Project	IEEE 802.16 Broadband Wireless Access Working Group < http://ieee802.org/16 >	
Title	UL ACK Channel Enhancement	
Date Submitted	2004-06-25	
Source(s)	Myung-Kwang Byun, Seungjoo Maeng, Jaeho Jeon, Soonyoung Yoon, Panyuh Joo	mk.byun@samsung.com
	<p>Samsung Electronics Co., Ltd. Dong Suwon P.O.Box 105 416, Maetan-3dong, Yeongtong-gu, Suwon-city, Gyeonggi-do, Korea 442-600</p>	
Re:		
Abstract	UL ACK Channel Enhancement	
Purpose	Adopting of proposed method into P802.16e	
Notice	This document has been prepared to assist IEEE 802.16. It is offered as a basis for discussion and is not binding on the contributing individual(s) or organization(s). The material in this document is subject to change in form and content after further study. The contributor(s) reserve(s) the right to add, amend or withdraw material contained herein.	
Release	The contributor grants a free, irrevocable license to the IEEE to incorporate material contained in this contribution, and any modifications thereof, in the creation of an IEEE Standards publication; to copyright in the IEEE's name any IEEE Standards publication even though it may include portions of this contribution; and at the IEEE's sole discreti

Figure bb1—Subcarrier Mapping of UL ACK Modulation Symbols for PUSC

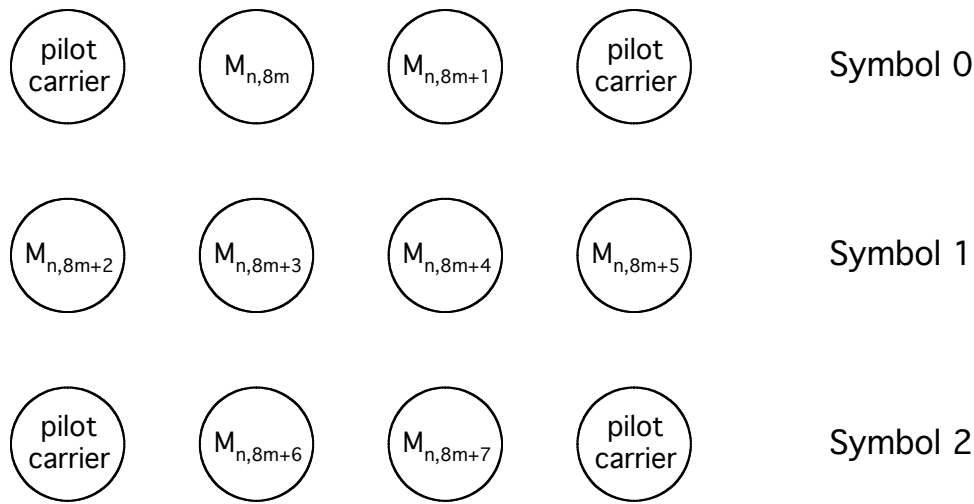
$M_{n,8m+k}$ is mapped to UL ACK channel tile as shown in Figure bb1 for PUSC uplink subchannel and in Figure bb2 for optional PUSC uplink subchannel. An UL ACK channel is mapped to half subchannel composed of 3 tiles.
